NFPA 1192-2026 Edition
Standard on Recreational Vehicles
TIA Log No.: 1867

Reference: Various in Chapters 2, 5, 7, 8, A.8.3.1.4, and D.1.2.5

Submitter: David Mihalick, Thor Industries, Inc.

Figure 8.3.1.7 Brake Wiring Diagram. [© 2014-2023 Canadian Standards Association]

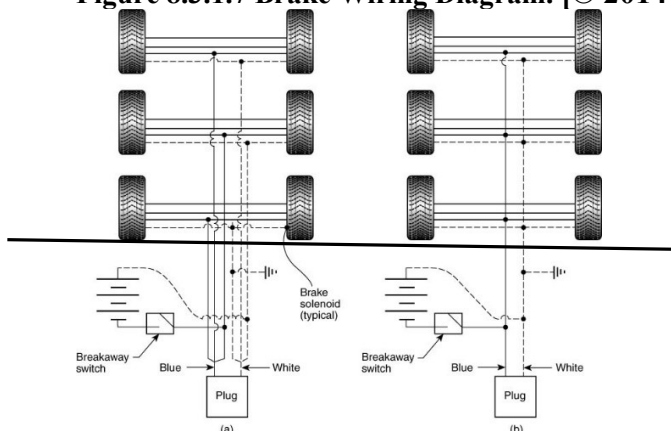
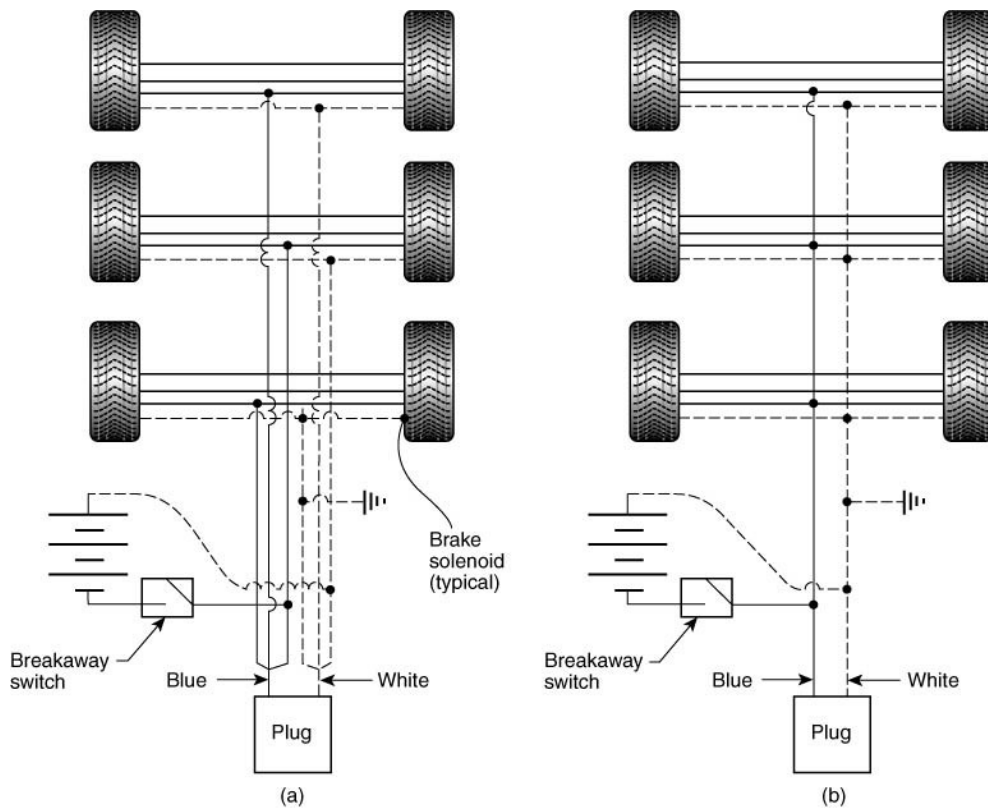
8. Revise 8.3.1.6 and 8.3.1.7 to read as follows:

8.3.1.7* Where electrically operated brakes are used, they shall be activated by a power source equivalent to or greater than that provided by a 12 V automobile battery, and wiring shall comply with SAE J1128 or equal. (See Figure 8.3.1.7.) [© 2014-2023 Canadian Standards Association]

Note: In diagram (a), the point of connection between the wire from the plug and the individual wires to each axle should be as close to the plug as practicable.

Figure A.8.1.2.2 Method of Determining Shortest Tongue or A-Frame. [© 2014-2023 Canadian Standards Association]

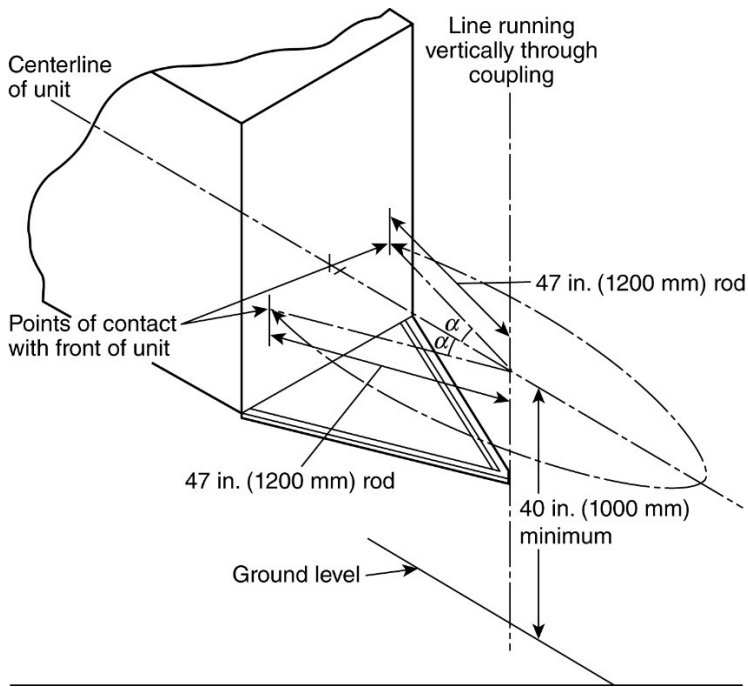
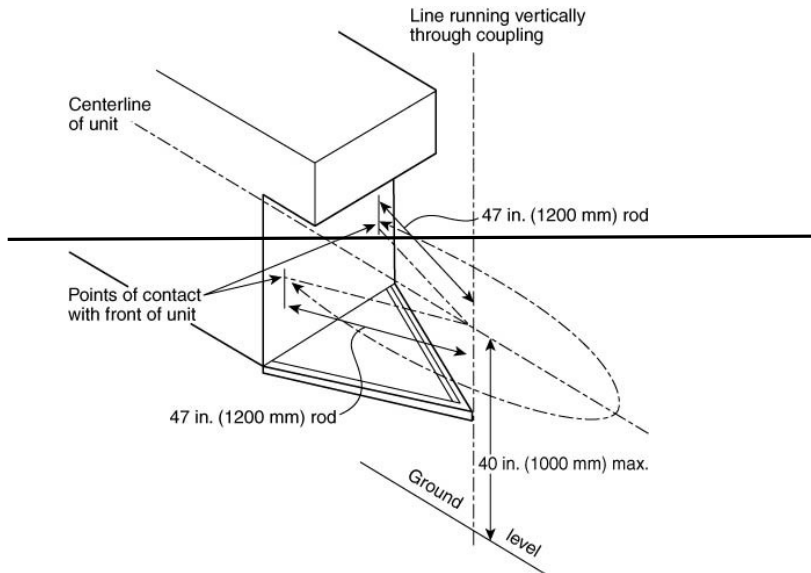
11. Revise Annex Figure A.8.1.2.2 to read as follows:

A.8.1.2.2 Figure A.8.1.2.2 shows the method to determine the shortest allowable tongue or A-frame.
